OBJECTION TO THE NORTHCONNEX PROJECT - SSI 13_6136

In response to the public exhibition of the Environmental Impact Statement (EIS) for this project I wish to record my objection to the proposal. My issues of concern are set out in detail below.

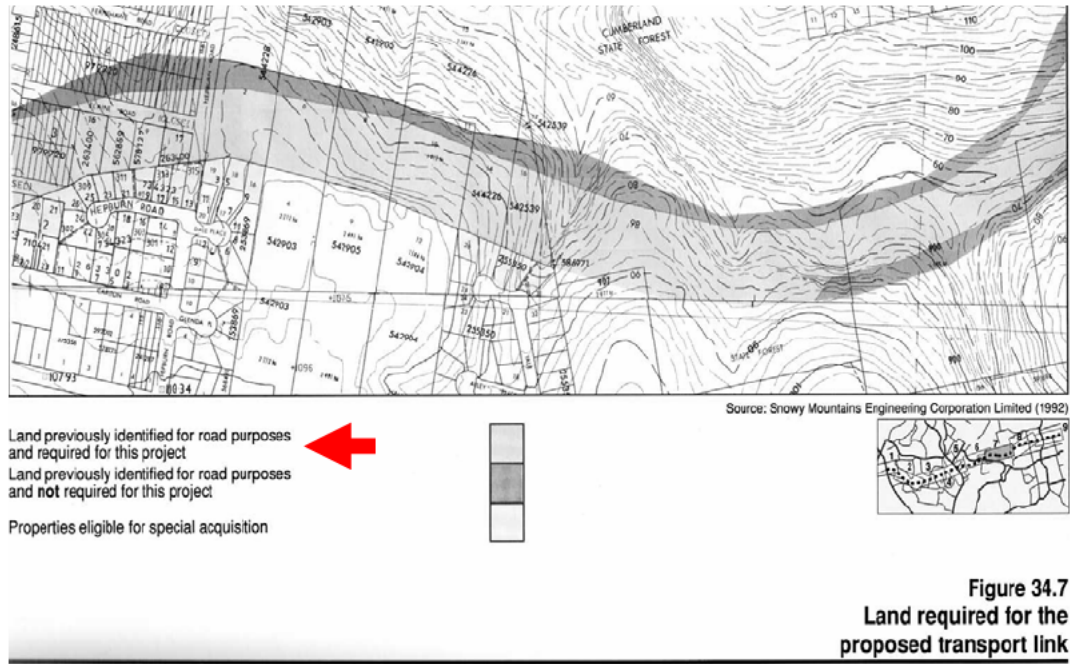
I object to the M2 being widened along its southern edge, adjacent to homes in Hepburn Road

and Dale Place. Any widening of the carriage way for the extra lane should be taken from land adjacent to the northern edge of the current carriageway for the following reasons:

- (a) Figure 34.7 from the original 1992 EIS, identifies various circumstances associated with the original M2 proposal. The area shaded dark grey is land noted as being '*previously identified for road purposes and **NOT** required for this project.*'

- Therefore land previously considered adequate for the purposes of this road exists adjacent to the northern edge of the current carriageway.
- (b) There are hardly any homes along the northern side of the M2 though Northmead, North Rocks, and Carlingford, as compared to its southern side. This can be confirmed by reference to aerial photos.
